Swedish Radiation Safety Authority

2014:07

Review of the geological mapping and  
geophysical measurement techniques for  
the determination of critical properties  
around deposition holes

Main Review Phase

**Figure 3:** Implications of the EFPC criterion: a) rejection of deposition hole (coloured red) where the extension of a FPI intersects a canister position; and b) rejection of multiple deposition holes where a fracture intersects at least five canister positions. From SKB R-11-14 (p. 19).

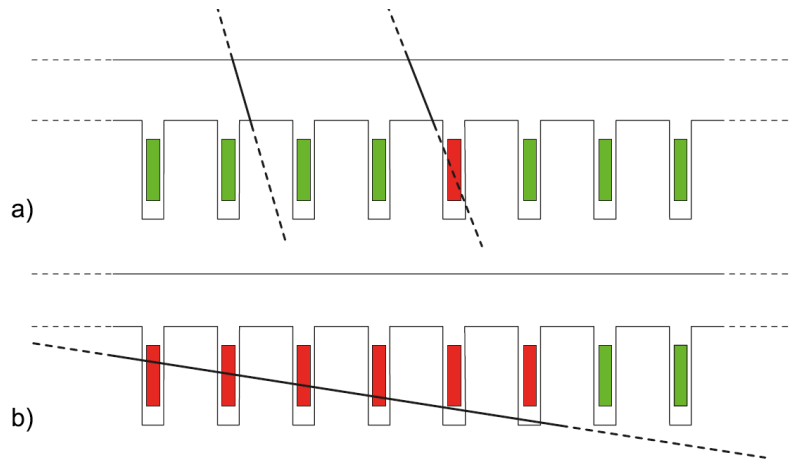
Thus, a critical radius of 50 m would appear to be a conservative lower bound for the assumed earthquake magnitudes, slip characteristics, and rock and fracture properties. Conversely, the question of conservatism depends on whether the assumption that fractures at 100 m distance from the source fault will not slip more than twice as much as those at 200 m is valid (see SKB TR-08-11, p. 119). Linear interpolation of the 3DEC modelling results reported in SKB TR-08-11 (pp. 82-83) would suggest this to be a fair assumption. However, it is recognized that the specific case of induced fracture shear displacements 100 m from the source fault was not directly modelled.

Conservatism incorporated into the EFPC is necessitated by the need for a robust and simple method to identify potentially discriminating fractures. As discussed in SKB TR-10-21 (p. 7), the full size of a fracture can rarely, if ever, be measured due to the limited exposure afforded by underground openings and limitations in relying on geological signatures or geophysical techniques (as reviewed in SKB R-06-39). Accordingly, the procedure proposed by SKB to identify discriminating fractures, with respect to mechanical stability and deposition hole approval (SKB R-11-14, p. 50-51), involves the following steps:

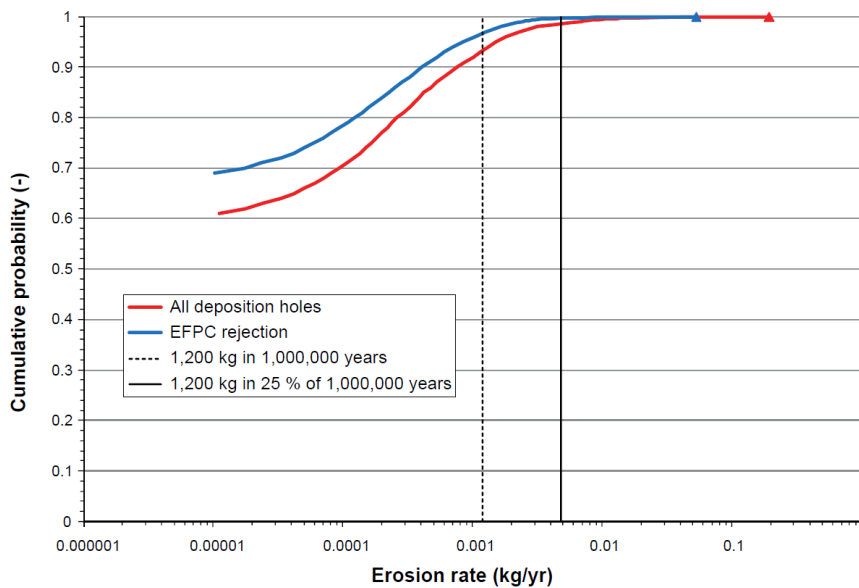
As noted in Table 3, SKB suggests that many high flow positions will likely be screened out by the application of the EFPC. This is based on the frequently observed correlation between fracture size and transmissivity such that application of the EFPC would reduce the number of high Darcy flux deposition holes significantly (SKB TR-11-01, p. 765). Additional inflow monitoring would then be carried out to ensure conformance to the Design Premises. SKB projects that only a few additional deposition holes, up to 6% in the most extreme case, will be rejected due to measured inflows higher than 0.1  $\ell/s$  (Figure 4; SKB TR-11-01, p. 158).

**Figure 5:** Surface intersection of major deformation zones along western margin of repository target area. Modified from SKB R-07-45 (p. 166).

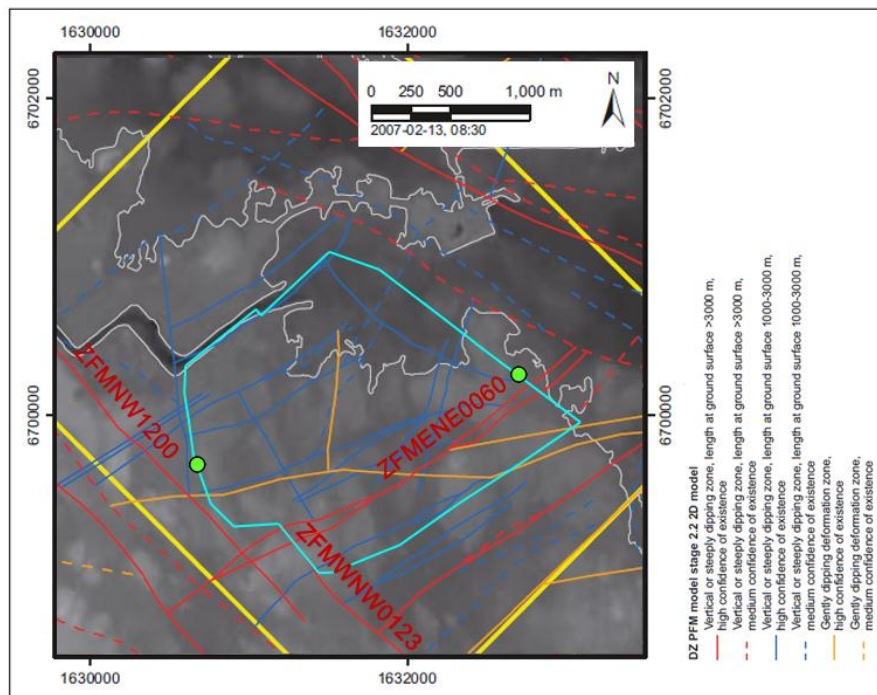
- The long-term function, if any, that grouting is expected to play could not be found.
- Some of the uncertainties to be managed by the Observational Method will not be resolved until after construction and operations are well underway (e.g. the presence of adverse geology/fractures in the farther reaches of the repository). It is not clear what the implications would be (in terms of project risk) if the rejection ratio of deposition holes increased after the options for adapting were significantly more limited. For example, inspection of the geological data reported in SKB R-07-45 indicates that the western margin of the target area borders a major tectonic feature that appears to be a splay(s) of the Eckarfjärden regional deformation zone (see ZFMNW1200 and ZFMWNW0123 in Figure 5). It is very likely that the rock mass conditions encountered in this part of the repository will be more tectonically disturbed, and therefore contain significantly more discriminating fractures than the rock mass encountered in the central area. Implicitly assuming that the conditions will be homogenous throughout each rock or fracture domain introduces considerable risk.

**Figure 6:** Loss of deposition holes calculated for the most likely and unlikely stress models. From SKB TR-10-18 (p. 38).

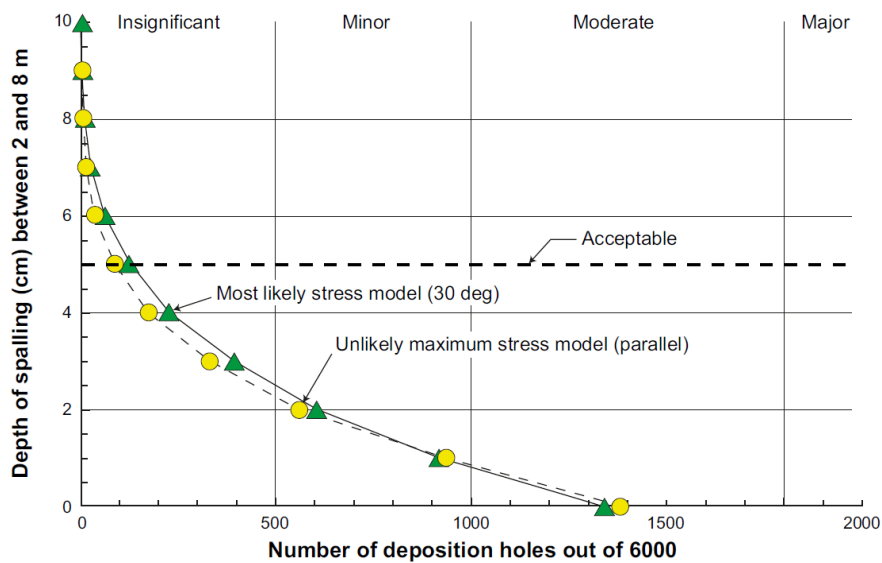
The implications of the current stress model are shown in the following plot (Figure 6) based on calculations summarized in SKB TR-10-18. The “unlikely maximum” values are obtained for a tunnel aligned parallel to the maximum stress (optimum orientation) while in the “most likely” scenario the tunnels are at 30° to the maximum. Not addressed, however, is the issue of tunnel construction in a direction aligned less favourably due to inaccuracies in the stress prediction. Verification is required.
